SANDBACH TOWN COUNCIL

Planning Committee

Supplementary Planning Application List to be considered at the meeting to be held on Monday, 9 August 2021 at 7.00pm in The Ballroom, Sandbach Town Hall.

Email received 4th August regarding Residential Cycle parking at Redwing Close, Abbeyfields Phase 2.

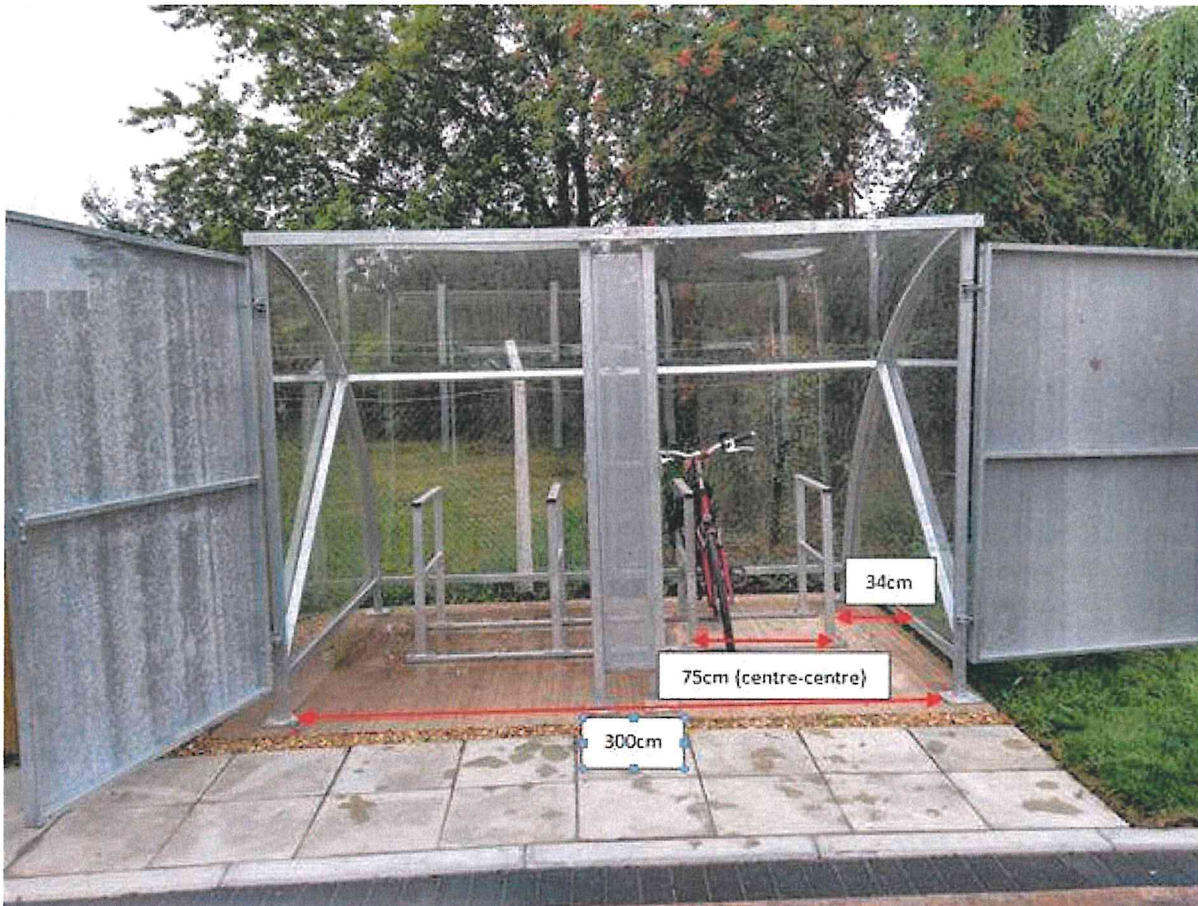
The shelter has a 'toaster rack' with 4 stands to accommodate in theory 8 bicycles. For reference I label the spaces from left to right 1-8, with the bike on the photo being number 6.

To make cycle parking more comfortable whilst maintaining the 4 available spaces I suggest to remove stands 2 and 4 (they are only screwed into the rail) and move the rack to the right hand side so that stands 1 and 3 are central behind the gate openings. That would result in comfortable distances of 150cm in the centre and 75cm at the ends.

Outer spaces

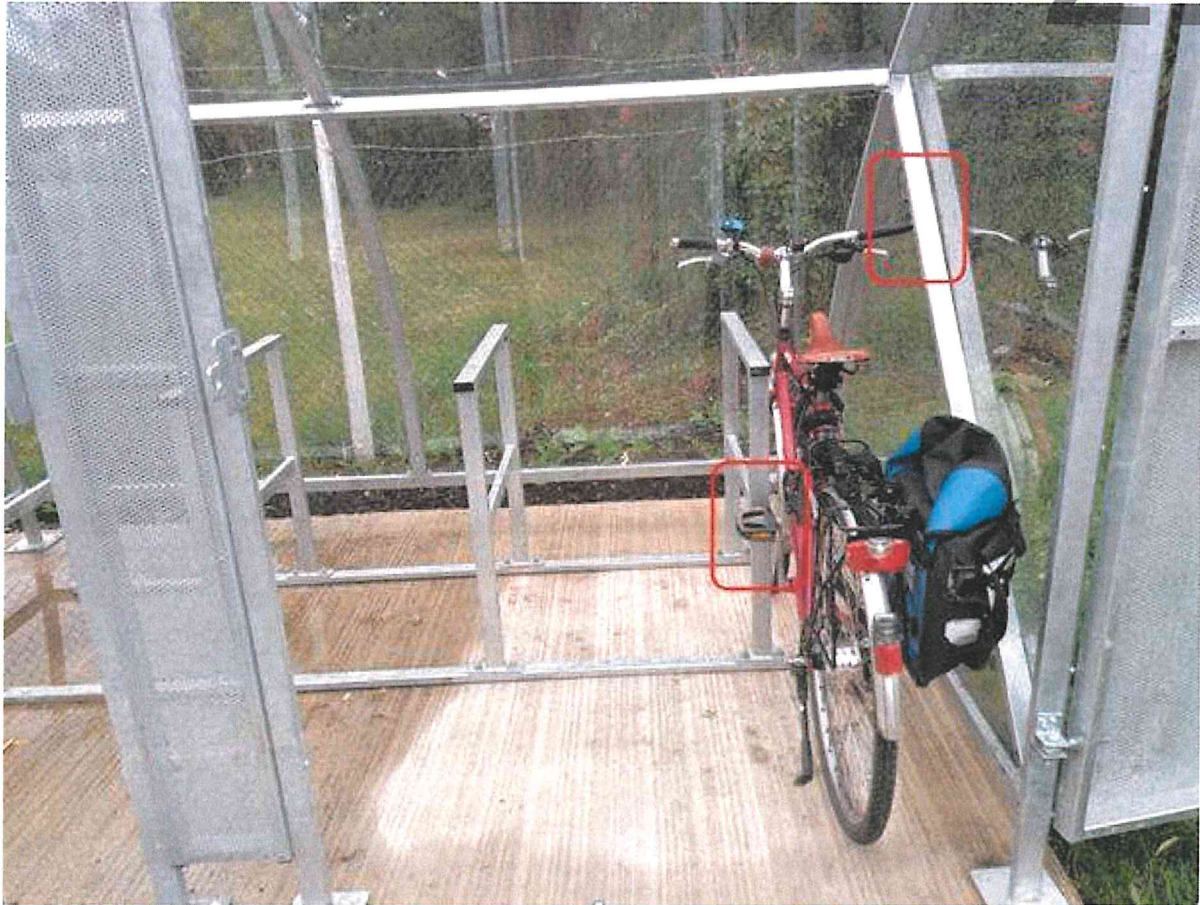
Cheshire East uses the excellent “Cycle parking guide for new residential developments” mentioned at <https://www.cheshireeast.gov.uk/planning/spatial-planning/cheshire-east-local-plan/supplementary-plan-documents/design-guide-supplementary-planning-document.aspx> (2nd May 2017). The guide states 60cm minimum for the outer spaces, 1 and 8. However the parking at Redwing Close offers only 34cm. The bike cannot be pushed in sufficiently as the pedal hits the stand. Even if it was parked at space 8, the right hand end of the handlebar would hit the perspex sheet, gradually damaging it.

Inside spaces

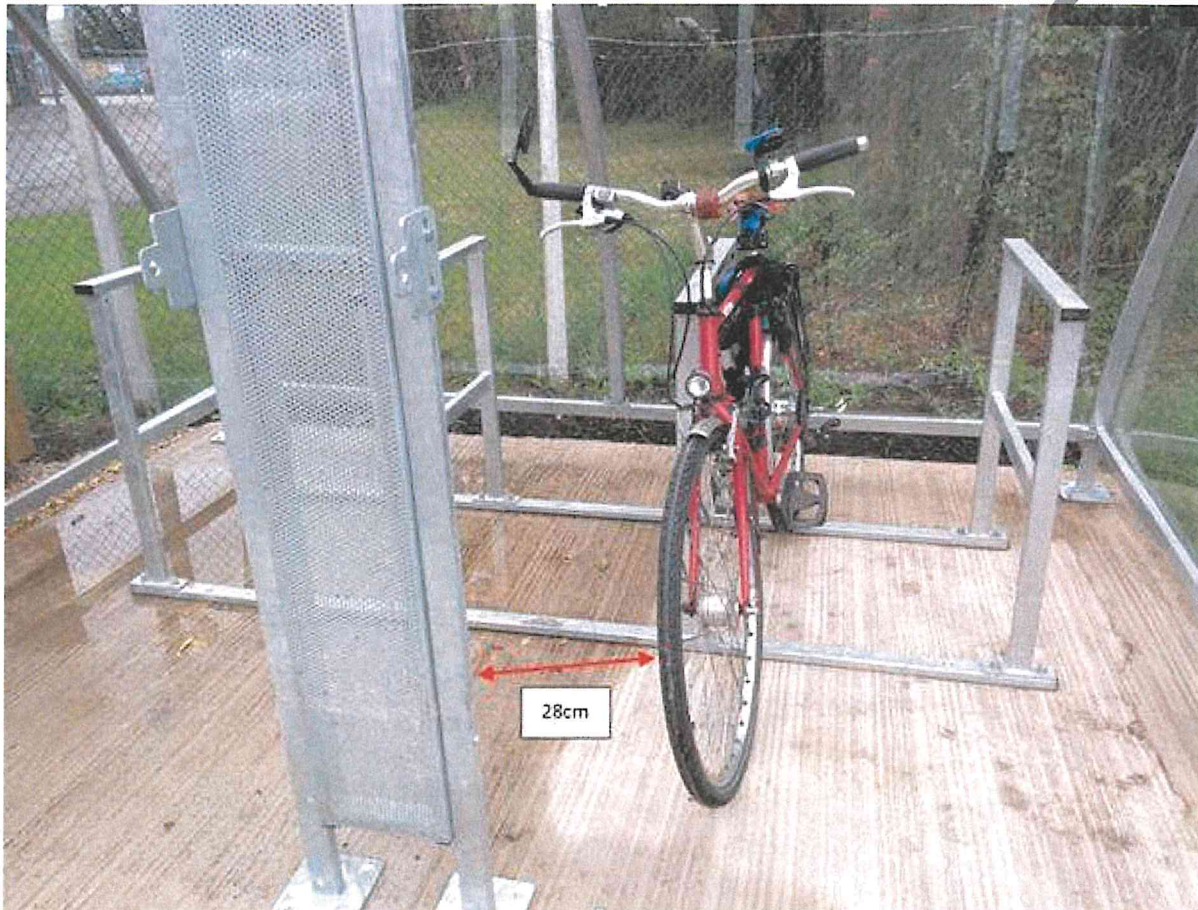
The guide states that 110cm is the width required for a cyclist pushing a cycle. The clearance between the central pillar and the wheel is 28cm which does not allow for a bike to be manoeuvred into parking space 5 (the guide shows the relevant dimensions for outer and inner swept paths too). Alternatively, a resident could find the shelter empty and parked on space 5. If space 6 is occupied later the bike in space 5 would be blocked in and could not be retrieved.

As mentioned above, 8 spaces are theoretically available, in reality only 4 can be used, 2, 3, 6 and 7, albeit not comfortably due to inadequate spacing between the existing stands.

Distance to the front wall and locking the bike

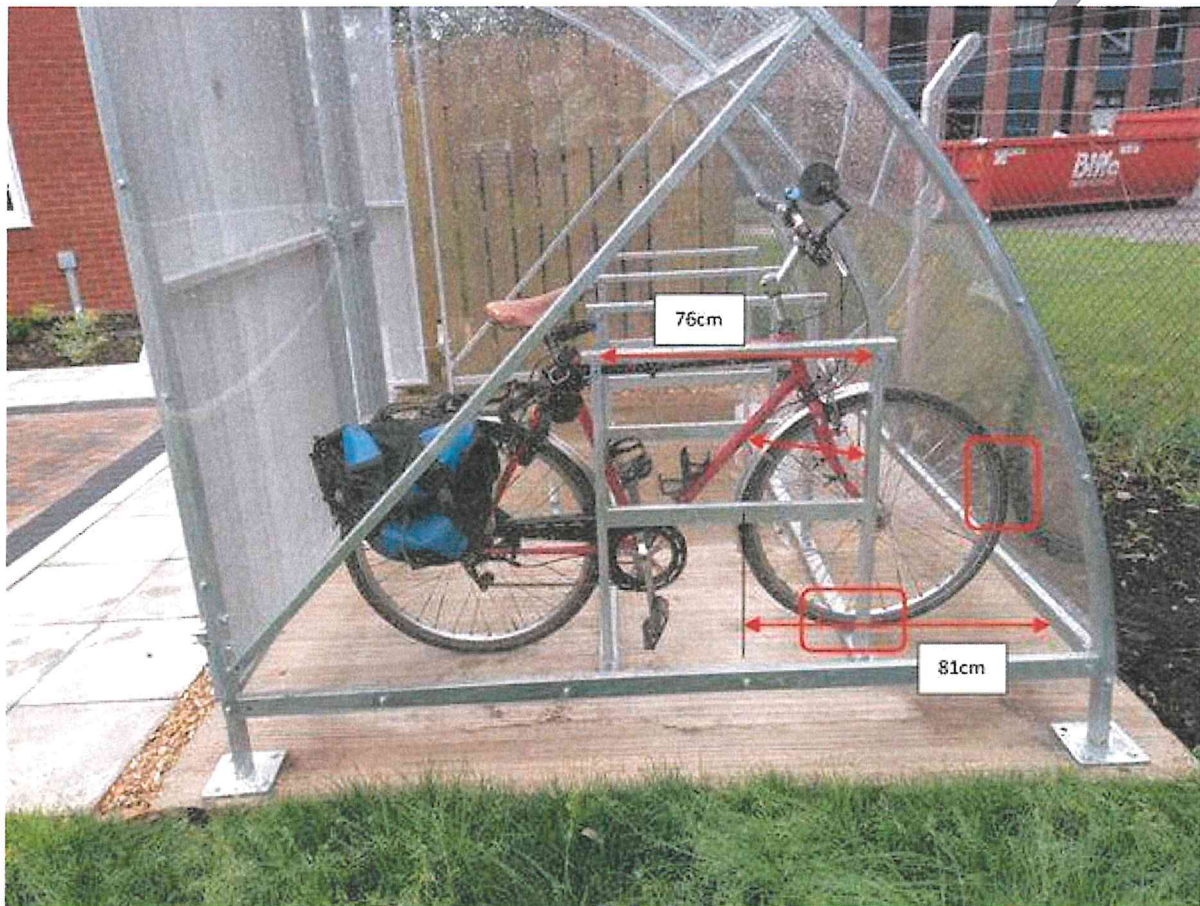
The guide states 100cm minimum centre of stand to the front wall/perspex screen. The current arrangement allows for only 81cm, resulting in 3 problems:

- the bike cannot be locked properly. Ideally the down tube+wheel should be locked to the stand with one D-lock, as indicated by the central arrow. See also further comments below under Security and durability.
- the front wheel should rest in front of the bottom rail. However, it rests on top of the rail, resulting in the bike rolling backwards when locking the bike, or rolling back later, resulting in a mudguard mounted rear light getting scratched by touching the gate.
- the front wheel touches the perspex, gradually damaging it. If parking backwards, as every other bike should, said mudguard mounted rear light gets scratched again.

The guide states 100cm as a minimum to 'allow cyclists room to lock their frames in comfort'. The current arrangement provides 75cm.

Additionally it is essential to move the rack away from the front perspex screen so the distance of centre-of-the-stand to the screen is the minimum of 100cm. This in return results in an even tighter angle when trying, but failing, to manoeuvre the bike into the central inside spaces. It supports the arguments to reduce the stands to only 2 or removing panel and gates.

As part of the earlier application 15/3379C, the area marked in red, drawing 1005-111D, was allocated to cycling.

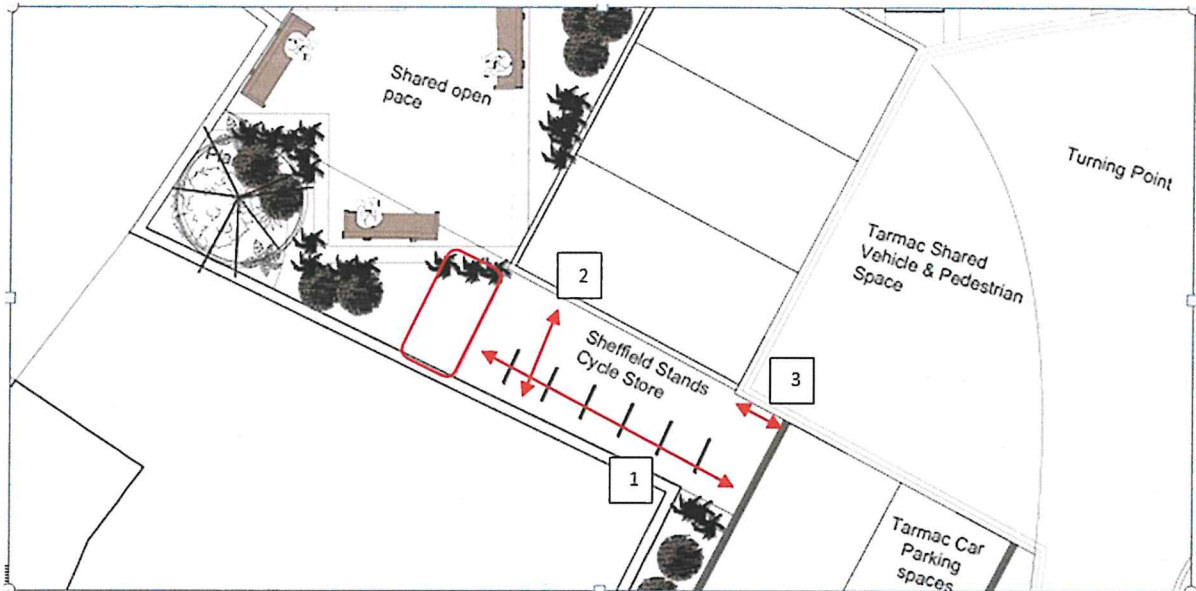
Planning reference 19/0349C, Condition 18 for cycle parking now relates to Drawing 1005 – 214D.

It is disappointing that the cycle parking area has been reduced. I would be grateful if clarified measurements for all three dimensions.

No3: access to the cycle parking area

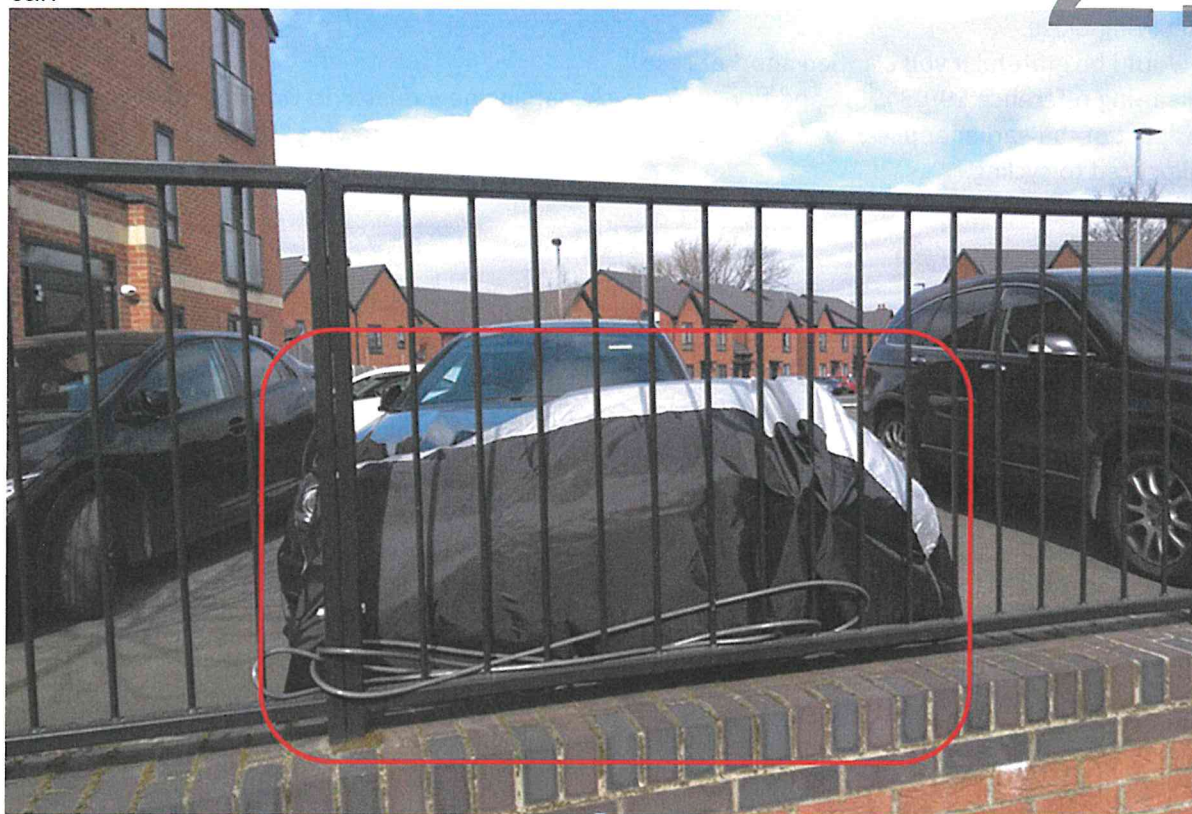
This should be a minimum of 1.10minimum
